Executive Director's Recommendation

Commission Meeting: June 6, 2019

PROJECT Hirshhorn Museum Sculpture Garden Revitalization Hirshhorn Museum and Sculpture Garden 700 Independence Avenue, SW Washington, DC	NCPC FILE NUMBER 7889
SUBMITTED BY Smithsonian Institution	NCPC MAP FILE NUMBER 1.16(38.00)44927
REVIEW AUTHORITY Federal Projects in the District per 40 U.S.C. § 8722(b)(1) and (d)	APPLICANT'S REQUEST Approval of comments on concept design
	PROPOSED ACTION Approve comments on concept design
	ACTION ITEM TYPE Staff Presentation

Wall Hierarchy

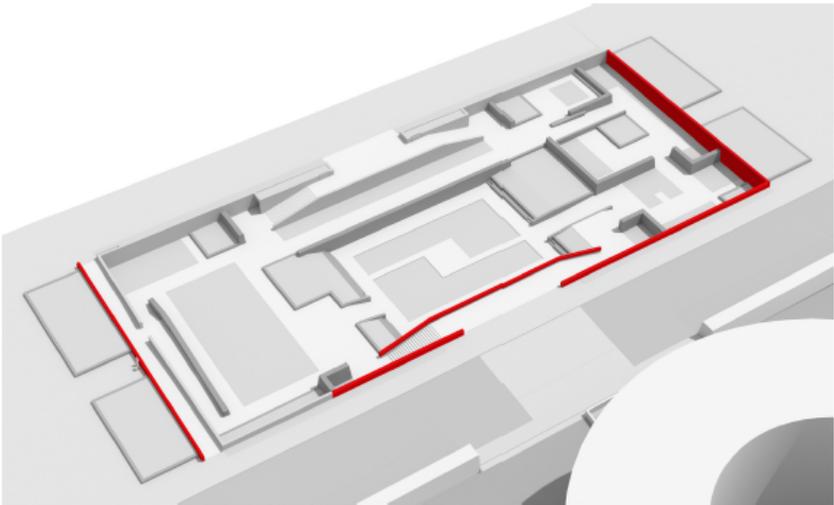
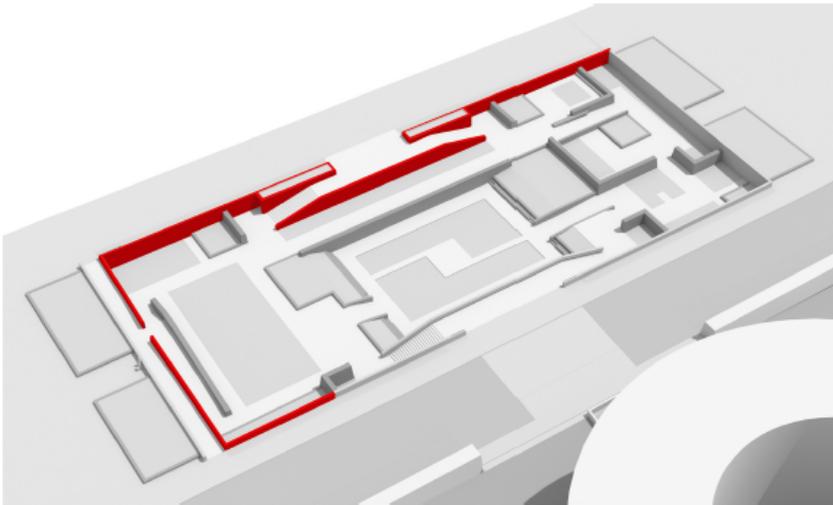
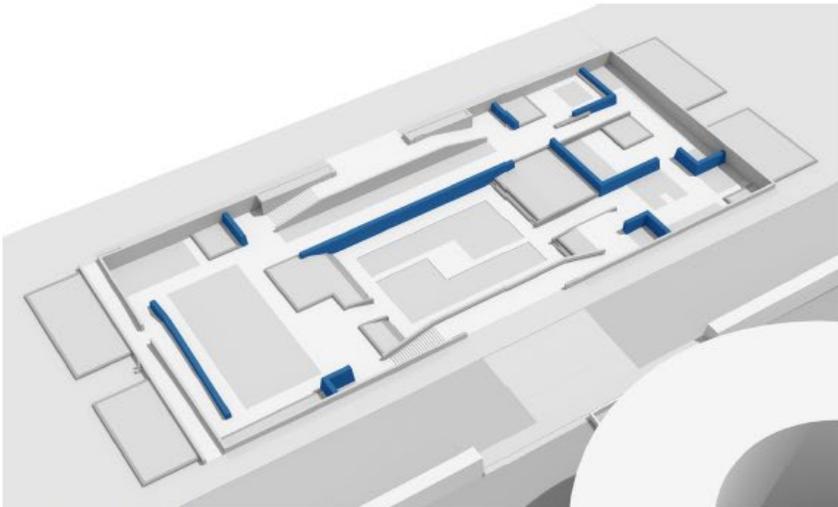
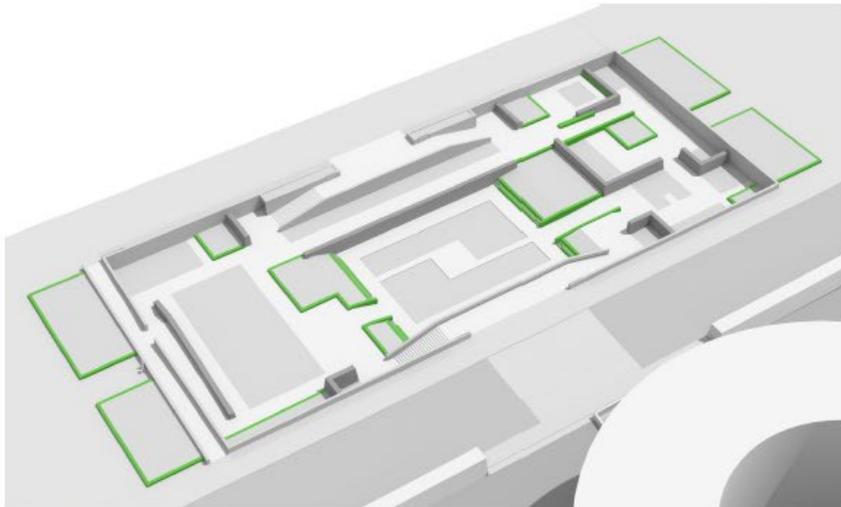
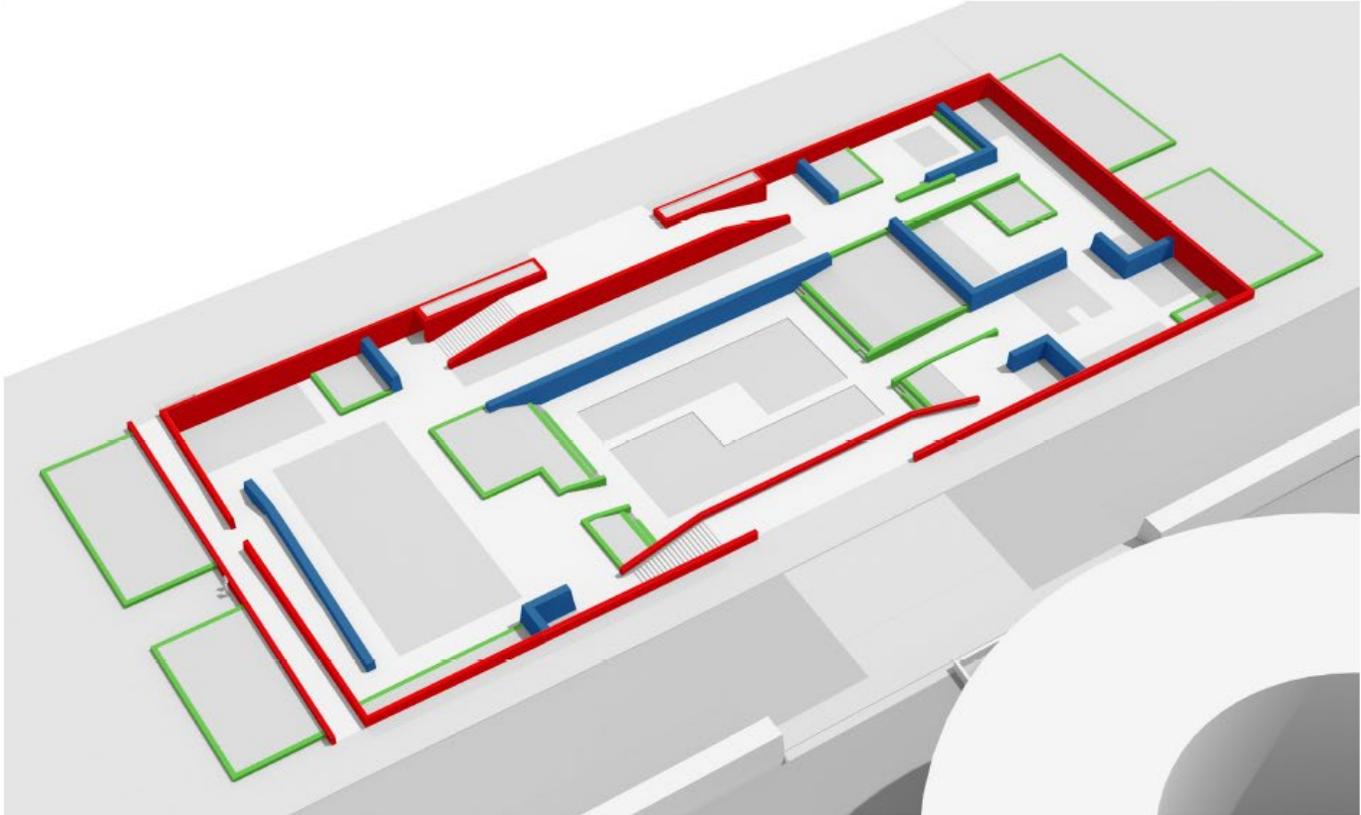
Supports the efforts to replace the failing original perimeter aggregate walls of Bunshaft's design with in-kind materials, to maintain these character-defining elements.

Notes the design proposes to remove the remaining Bunshaft design interior partition walls including the central partition wall, and the walls and ramps introduced by Collins in 1981, as part of the new revitalization.

Within the sculpture garden, walls mark the overall garden boundary, while serving as retaining walls, given the sunken nature of the garden. Under the concept plan, the original perimeter concrete aggregate walls that were part of Bunshaft's design will be replaced with in-kind material. According to SI, the replacement is needed due to the structural failing of the original walls. These walls will be re-built in the original locations, with the in-kind material consisting of sandblasted exposed crushed granite aggregate. The walls will also be slightly raised to meet current building codes. **Thus, staff notes existing perimeter wall and stone aggregate are contributing elements to the garden design and directly related the sculpture garden to the museum building. Staff recommends the Commission supports the efforts to replace the failing original perimeter aggregate walls of Bunshaft's design with in-kind materials, to maintain these character-defining elements.**

The walls installed under Lester Collin's work in 1981 will be replaced with new perimeter walls on the north, to complete the original shape of the garden at its perimeter. The material will be concrete aggregate to compliment the original Bunshaft wall material. The purpose of these walls is to define two new elements of the garden: the enlarged north overlook and the new ramped west entry to the garden. **Staff notes the design proposes to remove remaining Bunshaft design interior partition walls including the central partition wall, and the walls and ramps introduced by Collins in 1981, as part of the new revitalization.**

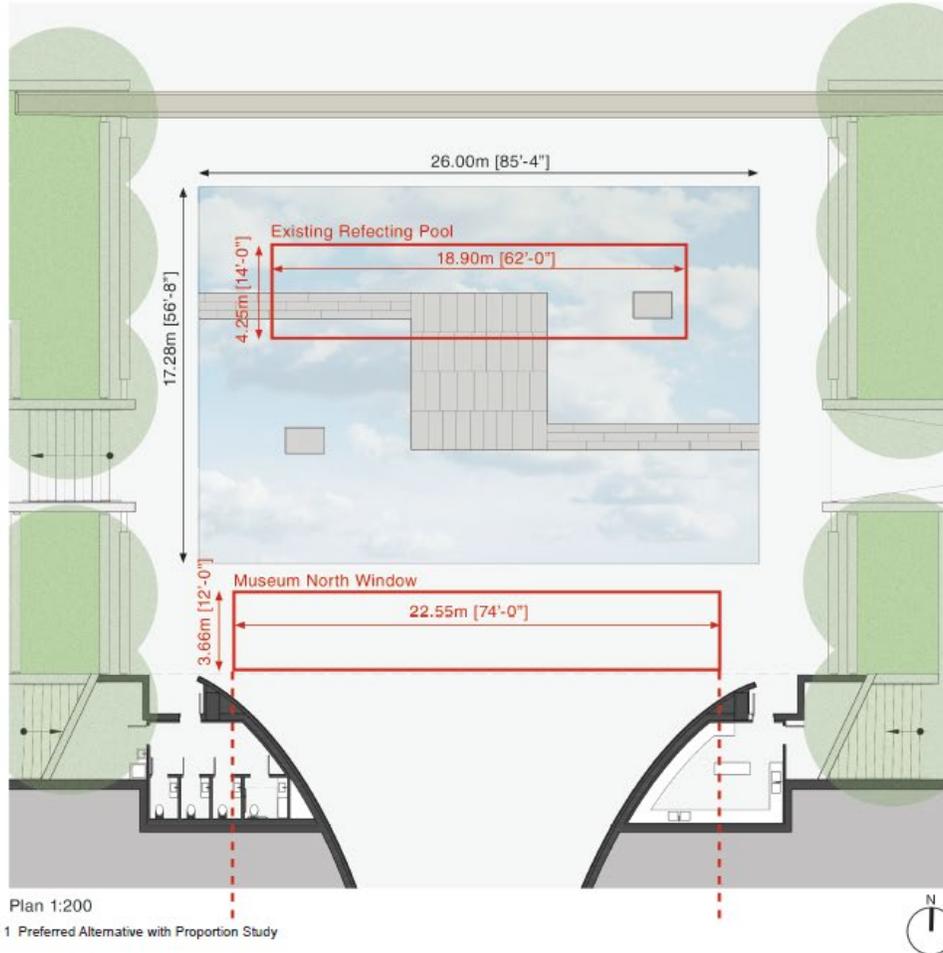
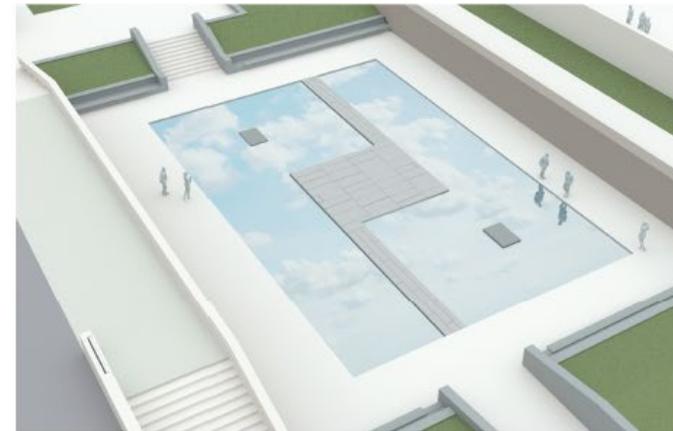
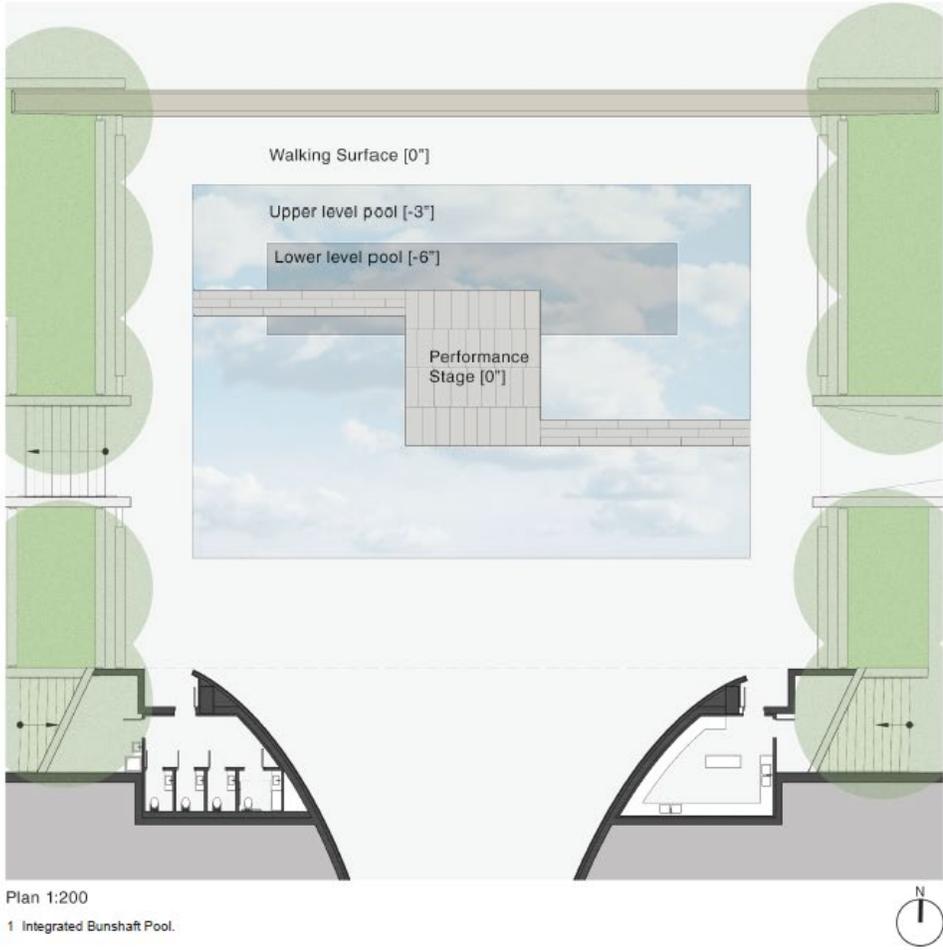
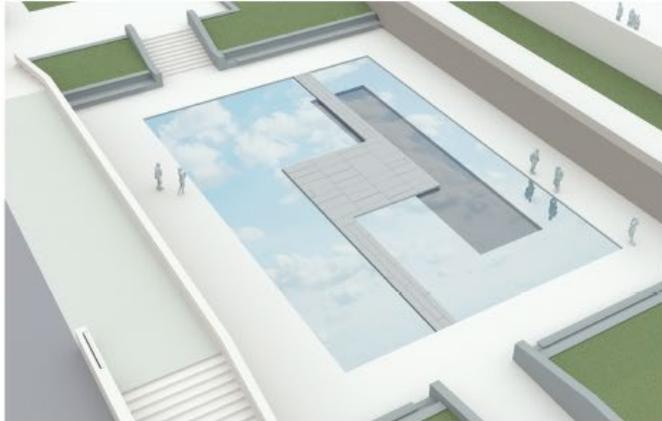
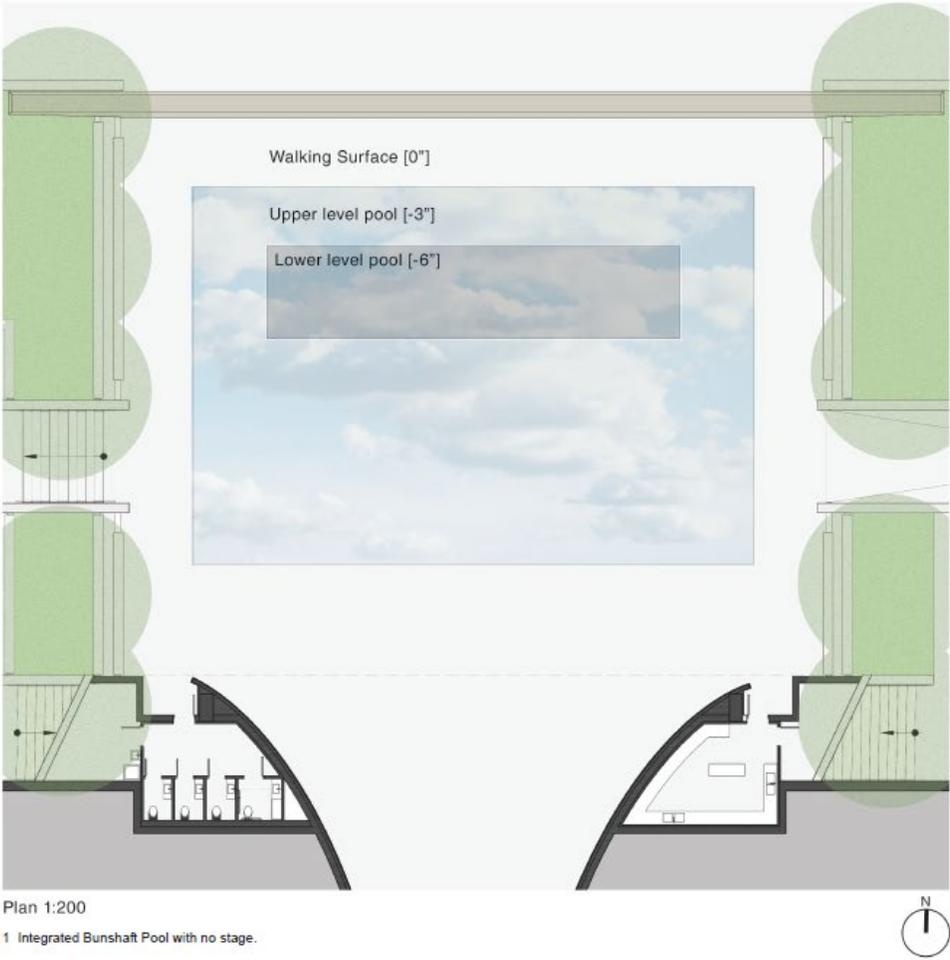
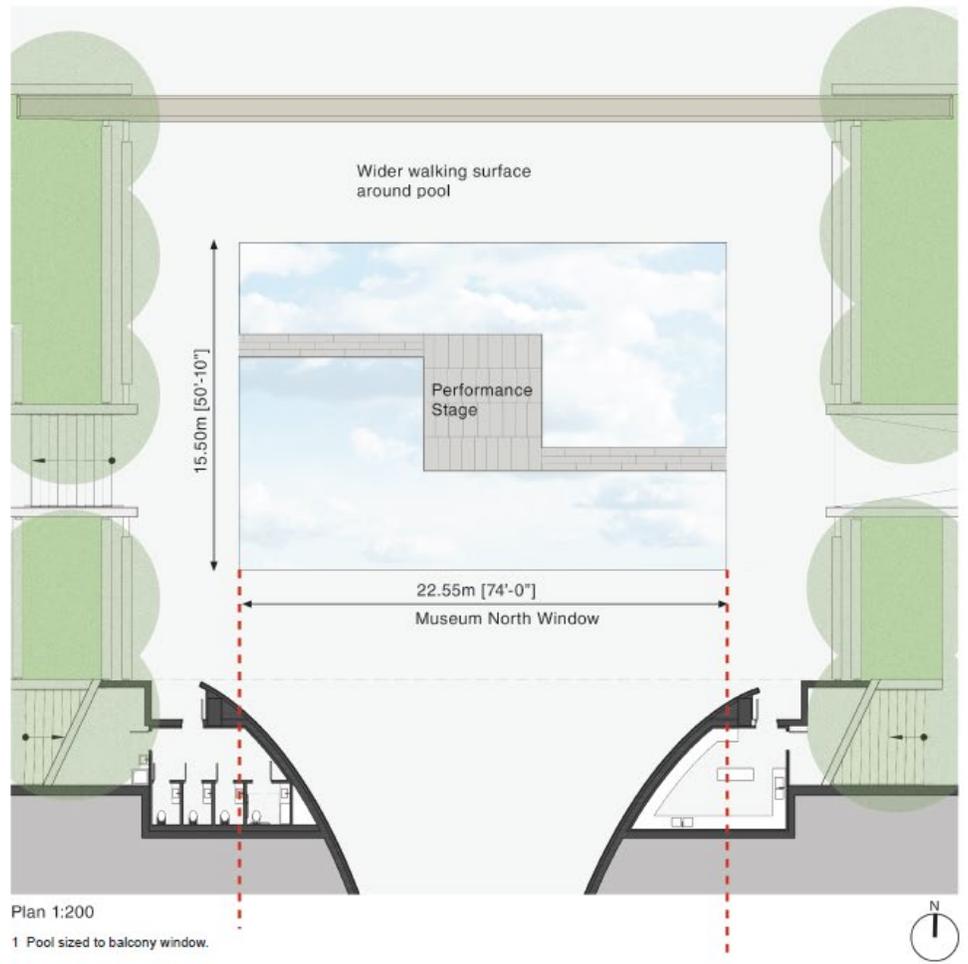
Requests the applicant provide additional details regarding the proposed pool modifications, including the design of the proposed stage and pedestrian paths, to demonstrate the impacts of any changes on the historic character of the pool and the visitor experience.

The concept plan includes several alternatives for a re-design of the reflecting pool, all of which significantly enlarge the pool. The first alternative incorporates an enlarged shallow reflecting pool with an integral performance stage and sculptural pedestals. The enlarged pool would be 85 feet four inches by fifty-six feet eight inches, compared to the existing reflecting pool of 62 feet by fourteen feet. The pool would be six inches in depth, and could be drained for performances. A second alternative incorporates the dimensions of the pool within the enlarged pool at two different recessed grades. This alternative does not have a stage, but could be drained for performances. A final pool alternative proposes to enlarge the pool and performance stage, but with reduced dimensions, that correspond to the actual width of the Museum's balcony's north windows. All alternatives would use honed black granite for the pool surface and stage components, and a lighter stone for edging.

Since the existing reflecting pool is an essential character-defining feature of Bunshaft's design, staff requests the applicant provide additional details regarding the proposed pool modifications, including the design of the proposed stage and pedestrian paths, to demonstrate the impacts of any changes on the historic character of the pool and the visitor experience. Furthermore, staff recommends the applicant explore a pool alternative that retains the historic character-defining dimensions of Bunshaft's pool design.

Alternative 1 - Entrance to Underground Passage

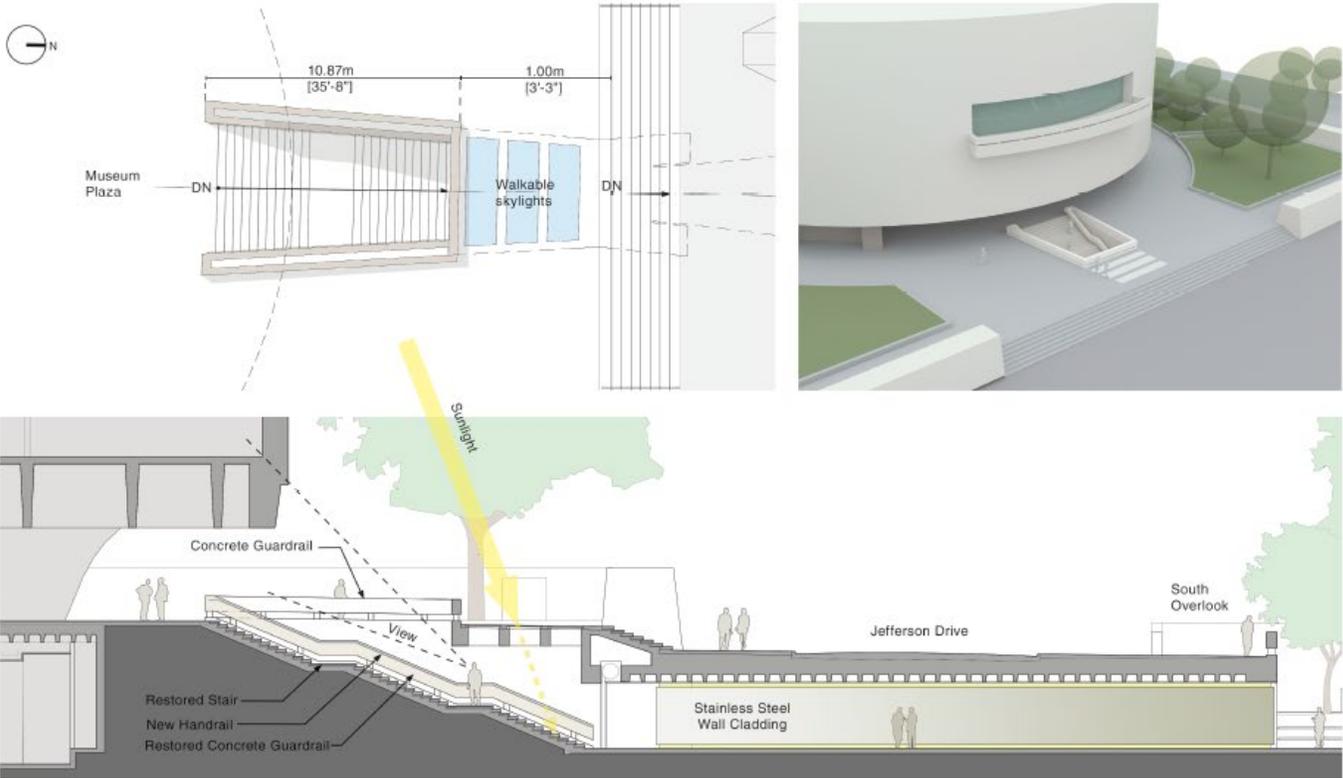
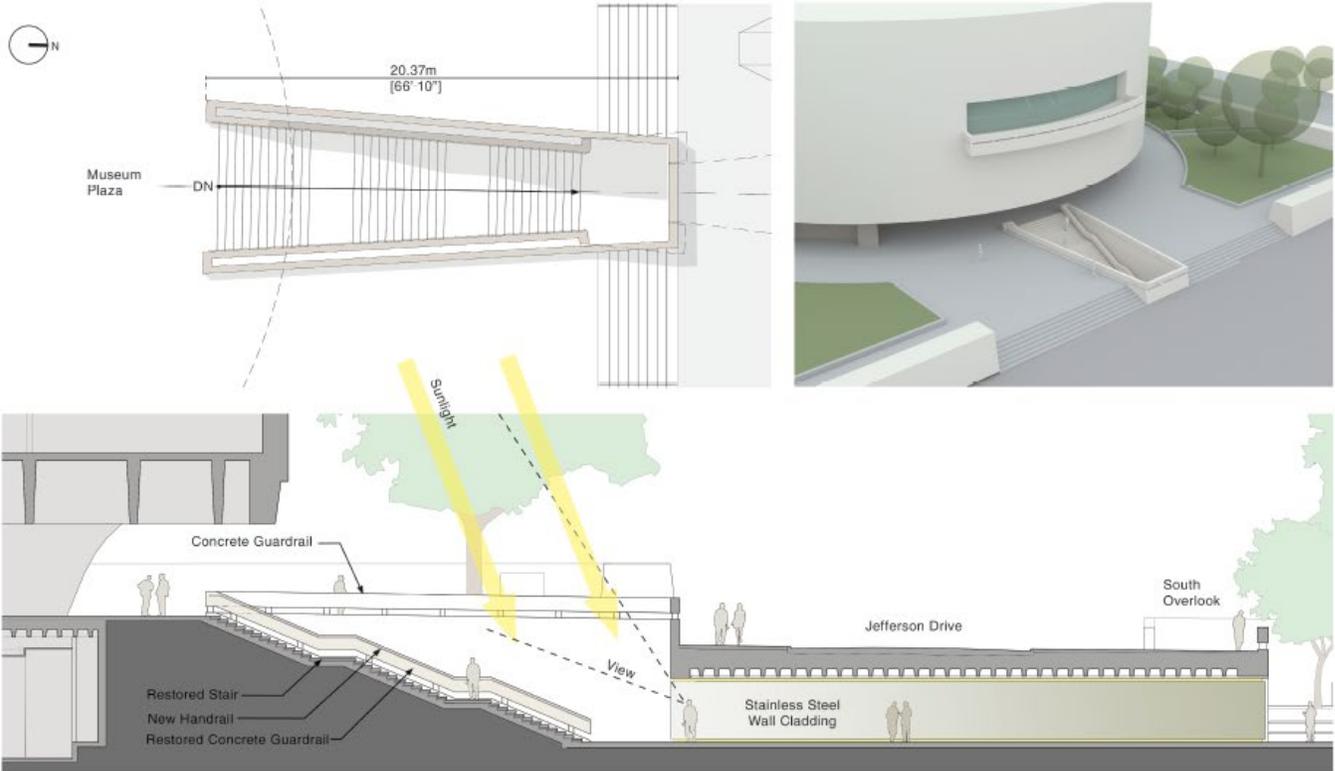
The concept plan proposes to introduce more light into the stair as they descend into the tunnel. This was one of the challenges with the original stair design, as it was dark and uninviting. The concept plans include several options to address this concern. The first alternative proposes to enlarge the stair opening, to bring daylight to the base of the stairs, while allowing visitors to view the building before ascending. This design would not impact the historic monumental Plaza stairs rising from Jefferson Drive. The tunnel's original granite stairs would be restored. The balustrade will resemble the original design but would meet current building codes.

The second alternative proposes to restore the stair entrance to its original opening size, and install a walkable skylight over the base of the stairs, to provide the desired daylighting. A third alternative proposes to maximize the enlargement of the stair passage to the tunnel but results in bisecting the monumental plaza entrance stairs.
